ATTACHMENT 3
WALKDOWN CHECKLISTS

Seismic Walkdown Checklist (SWC)

Project: CCNPP 2 SWEL

2PO5430 8-13-12 228

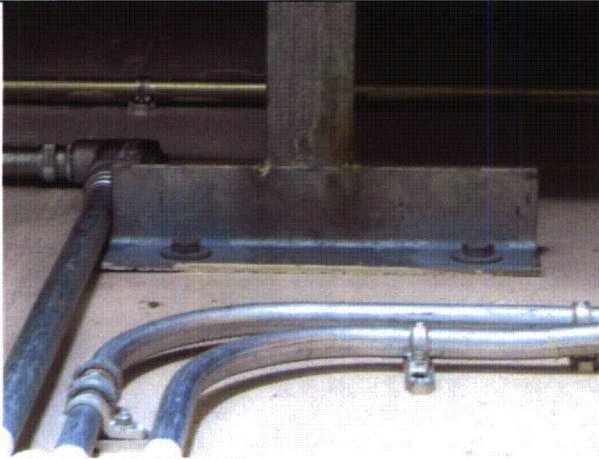
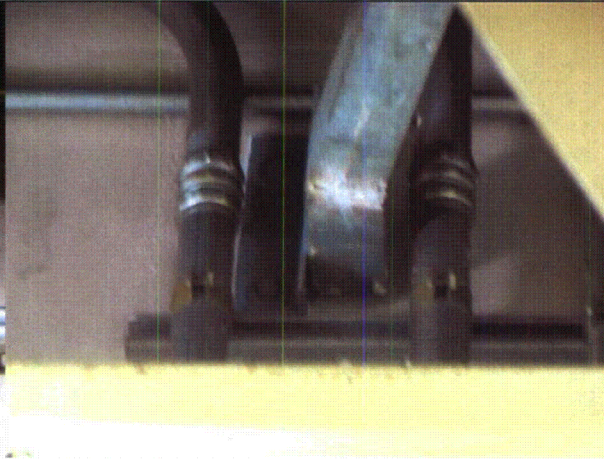
5. Is the anchorage configuration consistent with plant documentation? (Note: This question only applies if the item is one of the 50% for which an anchorage configuration verification is required.) No
Need plant documentation to determine if anchorage is consistent with as-built sketch. CR-2012-009778

6. Based on the above anchorage evaluations, is the anchorage free of potentially adverse seismic conditions? No
Need plant documentation to determine if anchorage is consistent with as-built sketch.

2PT5313A 8-7-12 030

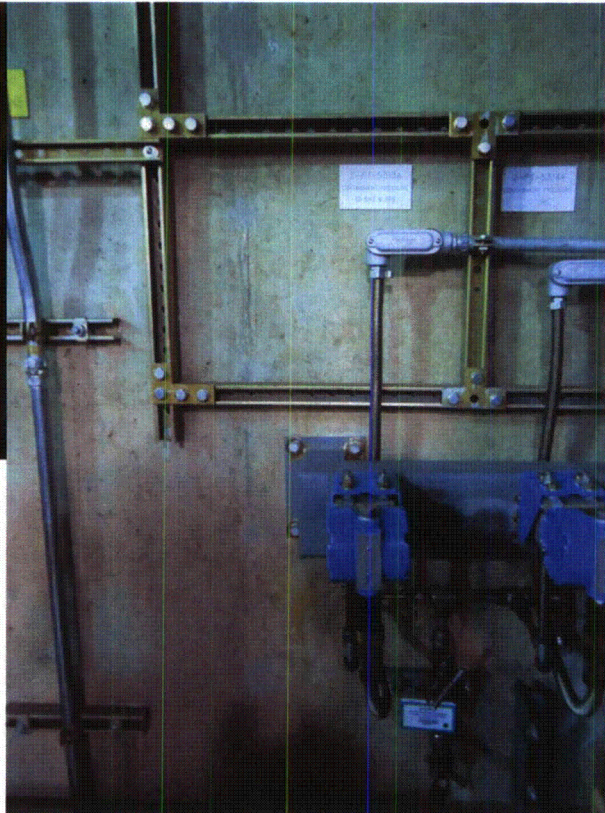
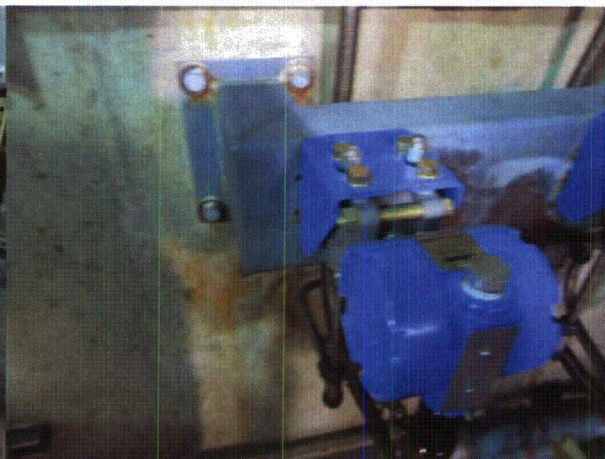
<i>Measured 3/4" F-F anchor bolt nuts in a 4-1/2" x 6-1/2" c/c anchor bolt pattern.
Only 3" long weld on vertical side of channel, not fully welded as shown on typical detail.</i> | Yes |

<i>Oxidation on bolts and corrosion on base plate. The left base plate is flaking.
CR-2012-009661</i> | No |

<i>Anchorage verified by Drawings 66944SH0002 and 91005(J-104). The web of the support channel is not fully welded to the wall anchor plates.
The channel's web weld is approximately 3" long instead of being continuous.
CR-2012-010259</i> | No |

2PT5313B 8-7-12 037

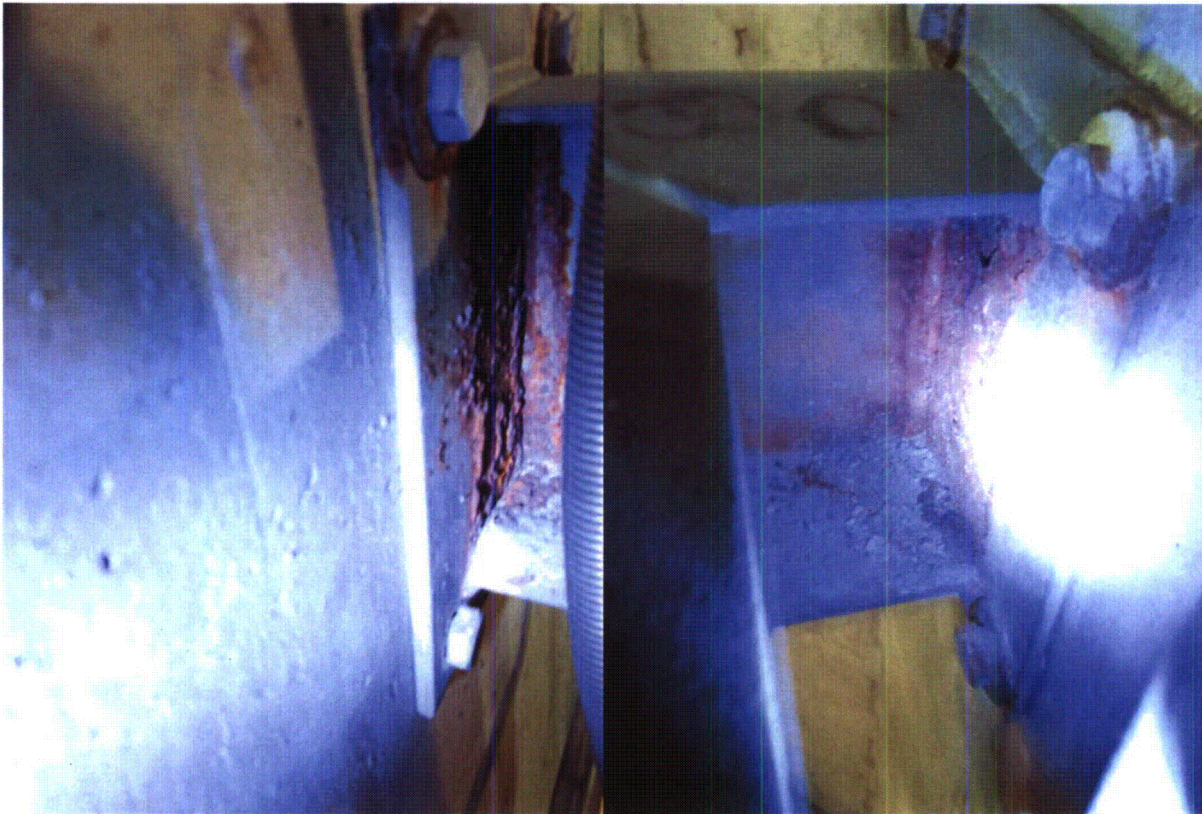
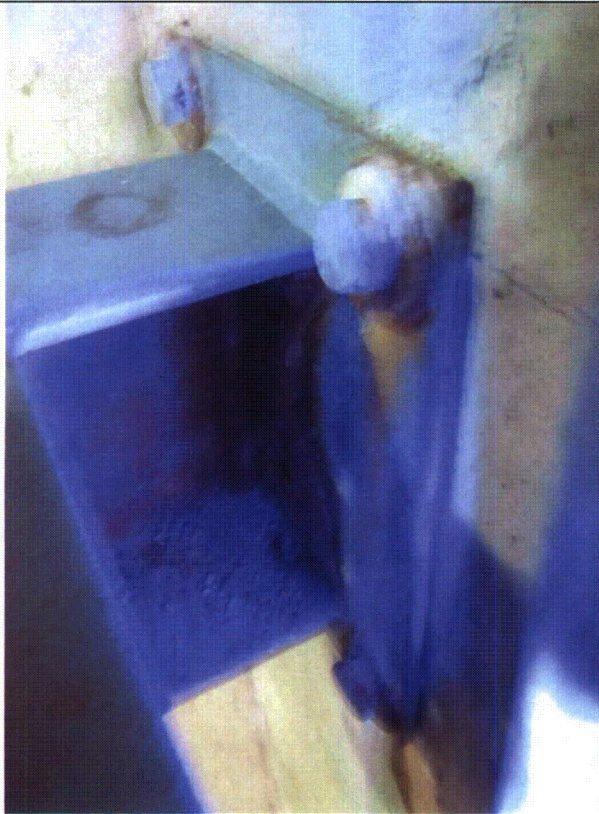
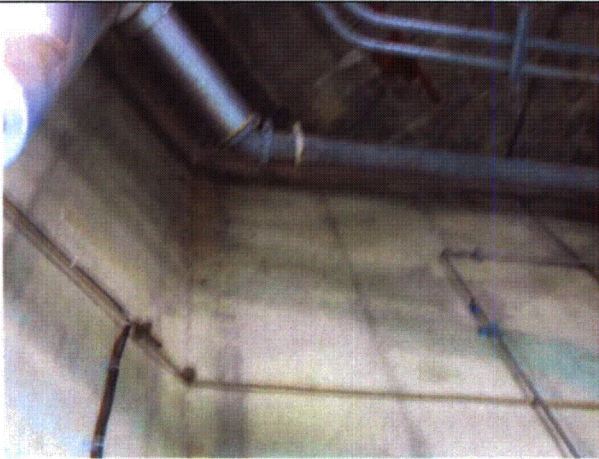
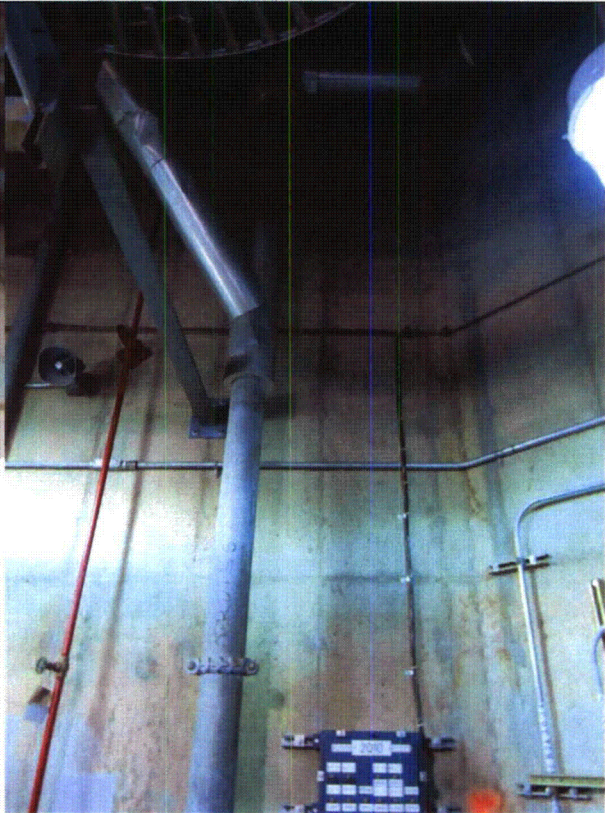
2. Is the anchorage free of bent, broken, missing or loose hardware? No
Missing anchor bolt washer. CR-2012-009624

3. Is the anchorage free of corrosion that is more than mild surface oxidation? No
*Corrosion and oxidation on Anchor Bolt and plate.
Base plate is flaking on both sides. CR-2012-009622*

2PT5315C 8-7-12 061

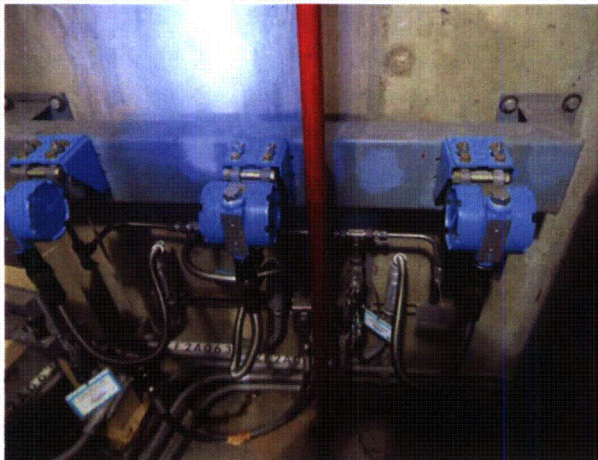
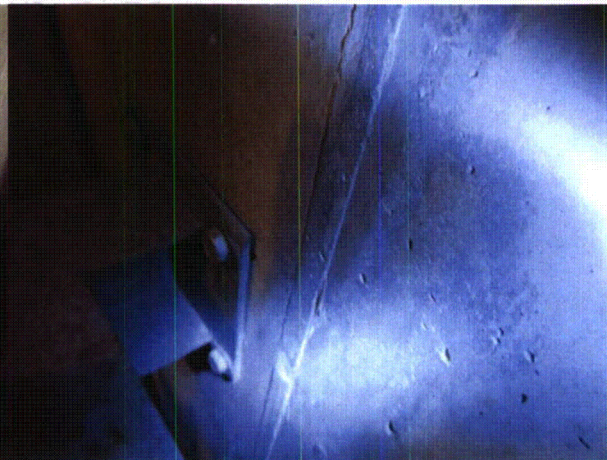
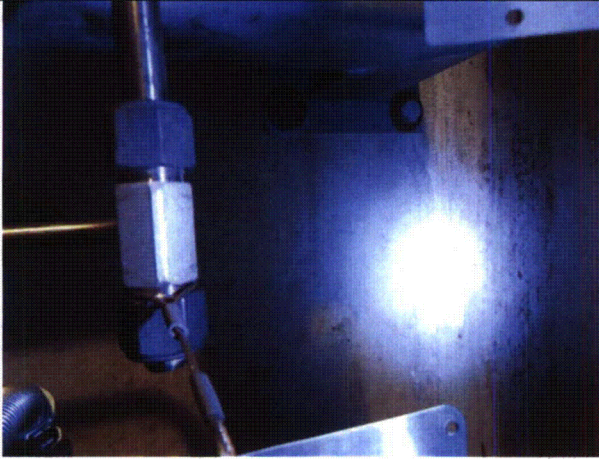
2. Is the anchorage free of bent, broken, missing or loose hardware? No
*Bottom bolts on right side not engaged.
Only 3" long weld on vertical side of channel, not fully welded as shown on typical detail. CR -2012-009754*
3. Is the anchorage free of corrosion that is more than mild surface oxidation? Yes

2PT5315D 8-7-12 068

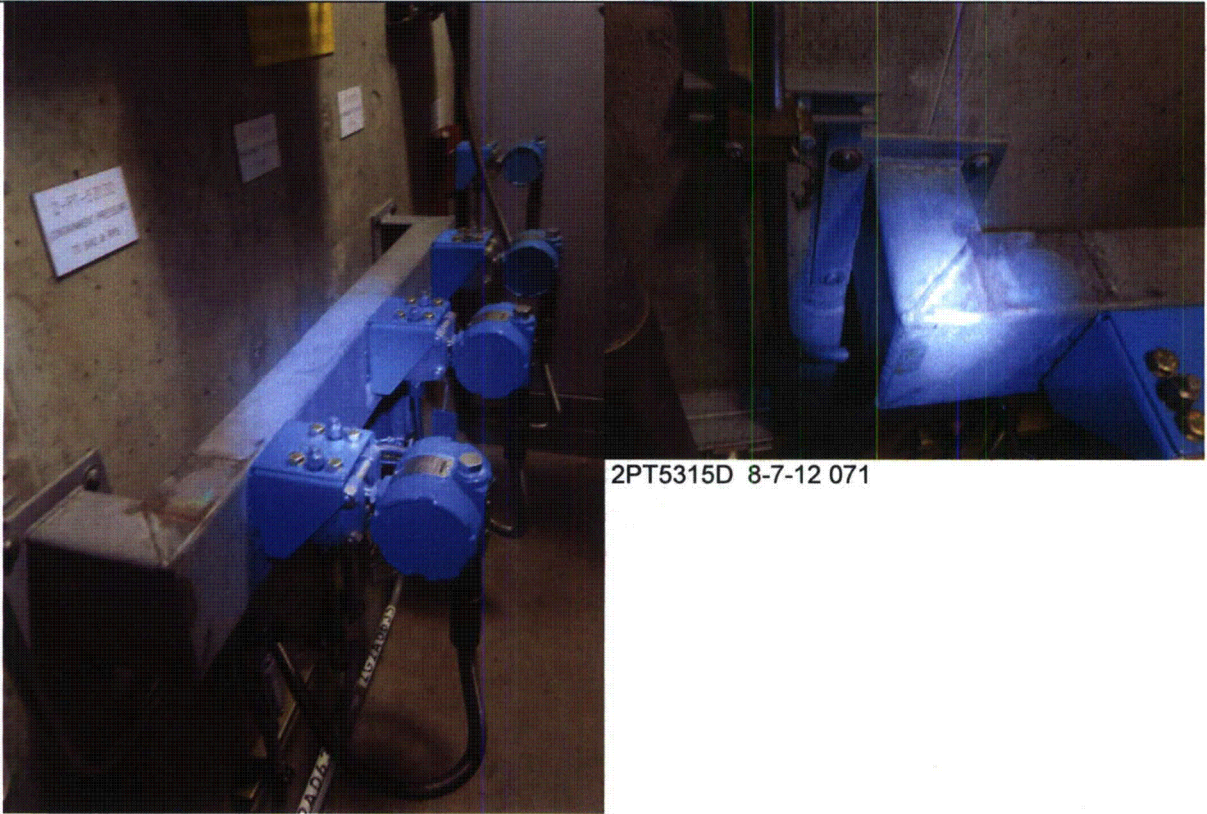
5. Is the anchorage configuration consistent with plant documentation? (Note: This question only applies if the item is one of the 50% for which an anchorage configuration verification is required.) No
Anchored by 4 x 5/8" flat head screw or 9/16" F-F headed screws (i.e. 3/8" nominal diameter bolts) in a 4.5" x 6.5" bolt pattern with only 3" long weld on-vertical side of channel, not fully welded as shown on typical detail. CR-2012-009714

Anchorage verified by drawings 66578 sheet 2 and 91005 (J-104). The web of the support channel is not fully welded to the wall anchor plates as shown on 91005.
